Access Compliance Report

Public Rights-of-Way

(Pedestrian Signals)

Intersection ID: N/A	Main Street:	Cross Street: N/A	Location: N/A
ADA ID: 0AECA7A457D0	Signal Type: One Push Button-Non APS	Overall Compliance: No	Severity Score: BTN 1: N/A BTN 2: N/A No BTN: N/A
Codes/Mitigation Info/Possible Solution		Field Measurements/Component Compliance

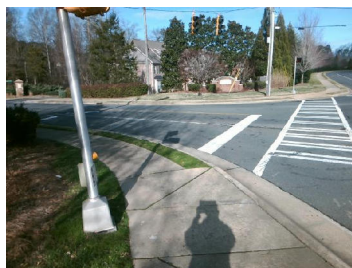
PROW/ADA: TMUTCD 4e.08, R404.2, R406.2, R404.7.3

Yes	B 1 Clear Xing Direction?	ClearlyMarked	N/A	B 2 Clear Xing Direction?	N/A
	B 1 Crossing Direction	To NE		B 2 Crossing Direction	N/A
Yes	B 1 DistanceTo XWalk (in)	18.0	N/A	B 2 DistanceTo XWalk (in)	N/A
No	B 1 DistanceTo Curb (in)	104.0	N/A	B 2 DistanceTo Curb (in)	N/A
Yes	B 1 Diameter (in)	2.0	N/A	B 2 Diameter (in)	N/A

Possible Solutions: Replace Signal Push Button With APS Button on New Post. Remove & Relocate Sign.
